RE: Cal Water Office Building

I reviewed the drawings, visited the site, had a telephone conversation with the architect to better understand their approach to the project, and prepared a review in September of last year. Since that time, the applicant has worked with staff on further refinements to the design. This letter is my follow up review on the new drawings that are to be reviewed by the Planning Commission.

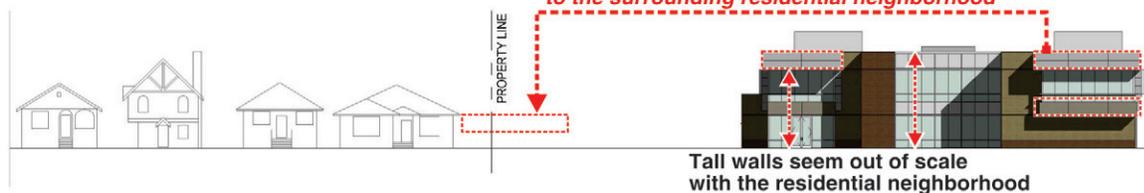
The earlier site plan showed a dead end parking aisle in the Guest Parking Lot on the southeast side of the new building which was highly undesirable. Visitors who entered, and were unable to find an empty space would have been unable to easily turn around, and would have to back out to the street. The applicant was able to block out one space to allow a vehicle turn-around.
